Proposal for a Supplement to the 01 series of amendments to Regulation No. 112 (Headlamps emitting an asymmetrical passing-beam)

The text reproduced below was prepared by the expert from Poland to introduce new optional "Class B1" headlamp. Photometric requirements for Class B1 are based on average real performance of present Class B (halogen/LED) but has no additional design restriction just like luminous flux of light source. The modifications to the existing text of the Regulation are marked in bold for new characters.

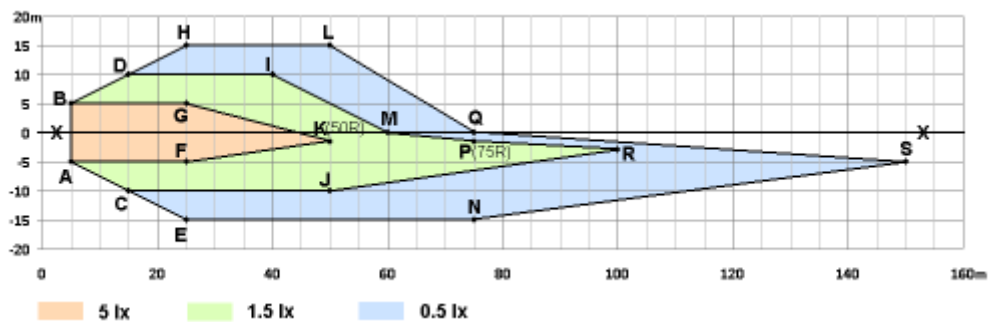
“6.2.4.2. **The passing-beam of Class B1 shall meet the luminous intensities described as follows:**

For right hand traffic luminous intensities shall be such that the vertical illumination defined for direction parallel to line connecting headlamp centre and given point at the road surface will be equal or more as described on the graph and in tables below.

Vertical illumination at the road surface to be recalculated for luminous intensities for single headlamp. Side: + Left, -Right; 0,0 – headlamp position at 0.75 m above road surface.

Area restricted by points	Minimum required value (lux)
A, F, K, G, B, A	5.0
A, C, J, R, P, M, I, D, B, G, K, F, A	1.5
C, E, N, S, Q, L, H, D, I, M, P, R, J, C	0.5

In any point and area the value of 100lx shall not be exceeded.

For left hand traffic all points and values should be mirrored with respect to X-X line.
